TITLE: PRELIMINARY PLAT NO. 01003, NORTH CREEK COMMERCIAL CENTER, requested by Engineering Design Consultants on behalf of North Creek L.L.C., for 10 commercial lots, with a request to waive the block length, on property generally located at No. 27th Street and Whitehead Drive.

Re: Preliminary Plat No. 01003
North Creek Commercial Center

P.A.S.#: **North Creek Commercial Center**
Change of Zone #3313
Preliminary Plat #01003

North Creek commercial center
SITE PLAN
 Lincoln, Nebraska

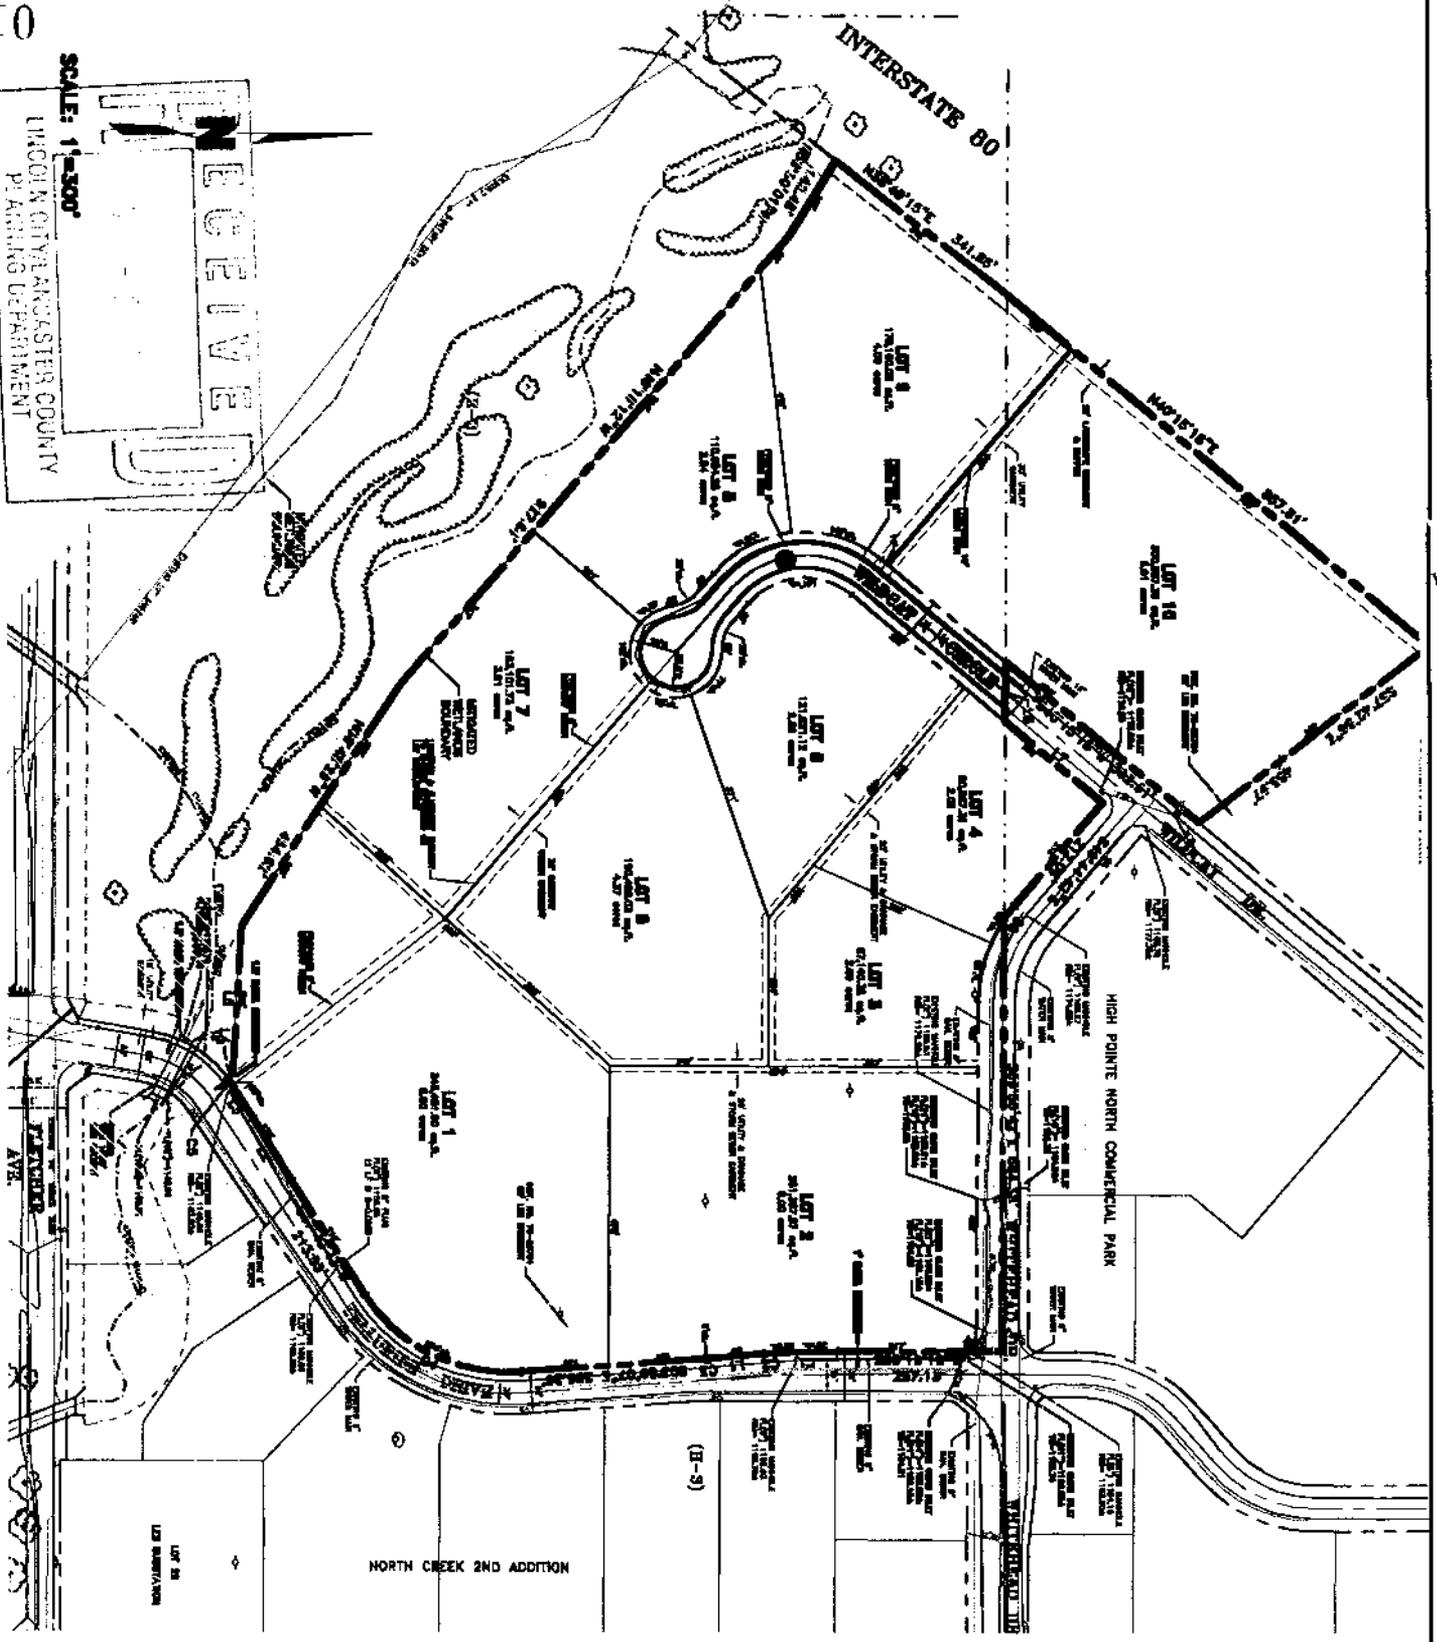
TRAFFIC ANALYSIS: Telluride Drive, Whitehead Drive and Wildcat Circle are local, commercial streets. Wildcat Circle should extend through the property and connect with Telluride Drive to provide adequate circulation and to avoid block lengths that exceed 1,320 feet.

10. The developer has requested a waiver of the block length requirement. Due to the location of the Interstate, and wetlands, this request is reasonable to the northwest and south. However, there is not justification why Wildcat Circle should not be extended to Telluride Drive to meet the 1,320' block length requirement and improve traffic circulation.

1. The proposed sewer and water systems shown are satisfactory.
2. The revised grading plan and calculations are satisfactory.
3. The block length from Whitehead to Fletcher along Telluride exceeds subdivision requirements. The request to waive this requirement does not meet the criteria for waiving this requirement stated in 26.23.130 of the subdivision ordinance. Engineering Services, therefore, recommends the waiver be denied.

Your preliminary plat has been reviewed by the county staff, the city staff and other agencies involved in land subdivision. The review found the plans will need revisions to bring them into compliance with the regulations. Those revisions include:

1. The proposed preliminary plat includes platted lots in the High Pointe North Commercial Park. The attorney representing the property owner has recently indicated that they do not want to include the existing platted lots in this Preliminary Plat. Rather, they intend to adjust the lot lines through a final plat process in the future. Please verify this information, and adjust the boundaries of the proposed Preliminary Plat accordingly.

2. Revise the boundary of the plat to clarify that "Outlot C" is not a part of the proposed plat.
3. Clarify which lot the triangular area at the southeast corner of Lot 1 belongs to. It is not shown in conjunction with either Lot 1 or Outlot C.

4. Clarify the lot lines and easement lines in Lot 1. A sanitary sewer easement appears to have a lot line included with it.
5. Add a note indicating that landscaping, signage and building design will be in accordance with the Annexation Agreement associated with the North Creek Trade Center Preliminary Plat, and the annexation of this property.

6. Note that the H-3 district requires a 30' front yard. A recent opinion from the City Attorney indicates that the frontage along I-80 is a front yard.

7. Clarify note 5. It does not appear that any public use easements are shown on the proposed plat.
8. Revise Note 8 to indicate that sidewalks will be constructed on the south side of Whitehead Drive and the west side of Telluride.

9. Revise Note 11 regarding total usage if the area from High Point is removed from the plat.
10. The Public Works Department noted that the existing and proposed water systems shown on the plat are adequate to serve the proposed lots in the plat.

11. The Public Works Department noted that no proposed sewers are shown on the site plan. Some lots shown are not served by existing sanitary sewer. The plan must be revised to show how all lots will be served.

12. The Public Works Department noted that the drainage and grading calculations submitted with the plat do not show how the major storms will be handled as is required by design standards.

13. The Public Works Department noted that no easements or overland flow routes are shown for the public storm sewer system outside the right-of-way downstream of Wildcat Drive.

14. The Public Works Department noted that storm water detention is not addressed with this application. A previous plat of North Creek Addition accounted for the runoff and detention requirements for the area of this plat. Since this is a new plat and the detention is outside this plat, the intentions of the developer including maintenance and construction responsibilities need to be acknowledged in this application.

15. The plans show 4 outlets from this plat into the 100 year flood area/flood corridor easement outside this plat. The plan grading does not show that water will reach these inlets. The concentrated flow will cause maintenance problems in the easement outside this plat. More detail is needed to show that the open drainage area is protected and will not degrade with the development plan as submitted. The portion of the easement within this plat should be shown on the site plan.

16. The traffic study for this area previously submitted depicted different land uses than is typically expected for the H3 zoning presently being requested. The study should be updated to acknowledge the presently proposed land use.

17. Revise the landscape plan to replace Scotch Pine with Colorado Blue Spruce or Black Hills Spruce. Scotch Pine are susceptible to Pine Wilt disease.

18. Revise the landscape plan to have only one notes section.
19. Revise the note regarding street trees to indicate that they will be planted in the right of way.

20. Remove "Note 3" regarding the landscape buffer between North Creek and the North Creek Trade Center as it is not applicable to this plat.

21. Revise the landscape plan to show the required street trees at the south end of Lot 2.
22. Provide the easements requested by LES.
23. The Health Department expressed concerns regarding H-3 zoning. However the proposed plat is not adjacent to residential uses.
24. The block length between Whitehead Drive and Fletcher Avenue exceeds the 1320 maximum. Extending Wildcat Circle through to Telluride would reduce the block length and meet the requirements.
25. The I-80 frontage requires street trees and sidewalks. Staff would consider a request for a waiver of the sidewalks since there is not a road cross-section showing sidewalks along the Interstate.

1. The High Pointe North Commercial Park Addition has been removed from within the Preliminary Plat Boundary.
2. A note has been added to the plan stating that Outlot 'C' is not part of this plat.
- 3 & 4. The triangular area is part of Lot 1. The line shown was a proposed sanitary sewer line and not a property line. The line has been changed and labeled as "sewer".
5. Note 25 has been added to the General Notes addressing landscape, signage and building design.
6. Note 26 has been added to the General Notes stating that a 30 foot front yard setback is required in the H-3 Zone.
7. Note 5 of the General Notes has been removed.
8. Note 8 of the General Notes has been revised to require sidewalks along Whitehead Drive and Telluride Drive.
9. Note 11 of the General Notes has been revised due to the elimination of the High Pointe Addition.
10. No Comment.

11. All lots are served by a sanitary sewer line. The lines have been revised and labeled for clarification.
- 12 & 13. The drainage table has been expanded to include calculations for the major storm and drainage swales added to convey the runoff to the detention facility.

14. Note 27 has been added to the General Notes addressing storm water detention.
15. Clarification notes have been added on Sheet 3, Grading & Drainage Plan, requiring design of the outlet structures during final design of the storm drainage system as part of lot development.

16. The traffic study completed as part of the overall North Creek Development (North Creek Development, Traffic Impact Analysis, Final Report, dated April 1999, by Olsson Associates) utilized land uses for this commercial area consistent with the H-3 Zoning. The presently proposed land uses have not deviated from what is allowed under the H-3 Zoning or what was intended within the traffic study. Any anticipated uses currently under consideration would generate traffic volumes that are less than those proposed by the study.

17. The Landscape Plan has been revised to replace the Scotch Pine with Colorado Blue Spruce.
18. The notes section on the Landscape Plan have been combined.

19. The Landscape notes have been revised to require street trees to be planted in the street right-of-way.
20. Note 3 of the Landscape Notes has been removed.

21. The Landscape Plan has been revised to add additional trees at the south end of Lot 2.
22. Easements requested by Lincoln Electric System have been shown.

23. No comment.
24. Due to the existing open channel and wetlands to the south of this site, we request a waiver of the block length between Whitehead Drive and Fletcher Avenue. Based on the proposed lot configurations for this plat and the existing adjacent roadway network, extension of Whitehead Circle to Telluride is not warranted or beneficial to development of this property.

25. We request a waiver to eliminate the requirement for sidewalks along the I-80 frontage.
